**STAFF REPORT: NOVEMBER 13, 2024 MEETING**

**APPLICATION NUMBER: HDC2024-00630**

**ADDRESS: 2310 EDISON**

**SCOPE: REPLACE WINDOWS (WORK COMPLETED WITHOUT APPROVAL)**

*1974 designation photo, HDAB.*

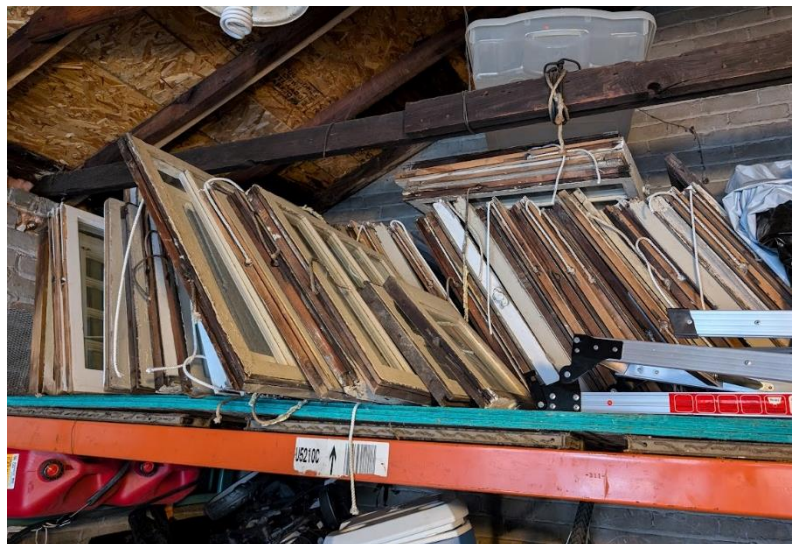
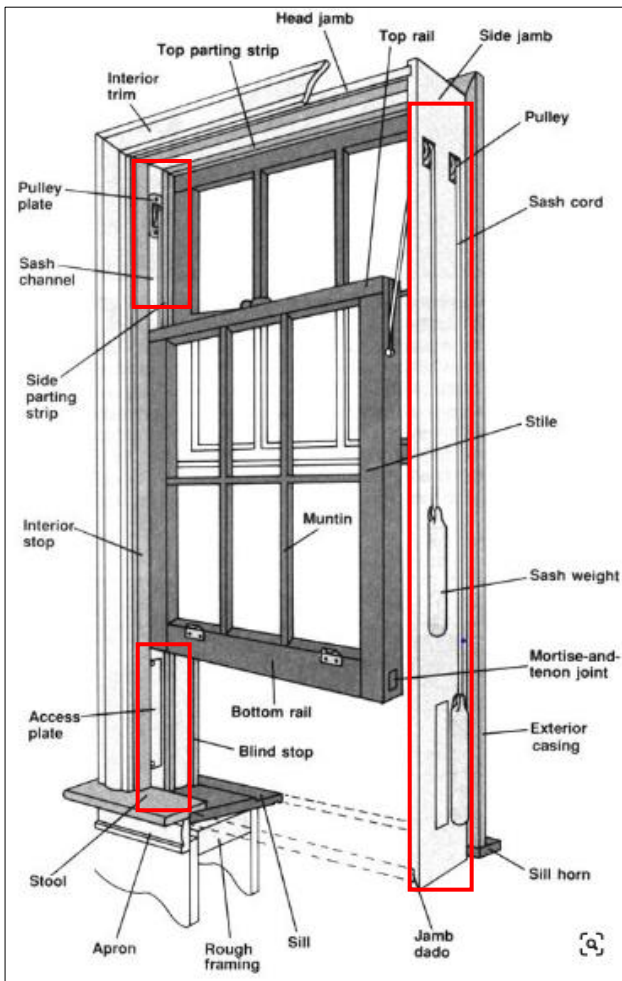
- The Boston Edison Historic District was enacted on April 2, 1974.
- The designation photo documents the original windows within the main bay of the facade. The grouped window opening at the first floor consisted of six narrow 18-lite (three-wide by six-high) casement units with leaded comes. The double-hung windows on the house had vertically divided multi-paned upper sash over single glass lower sash. The uniquely patterned windows on the house were common designs for arts and crafts-style houses and are identified as distinctive character-defining features.

- The leaded glass windows on the façade at the first floor (visible in the above designation photo) were replaced without Commission approval between 2011 and 2013, based on Google street view images. The remaining windows on the house were replaced in April 2024.
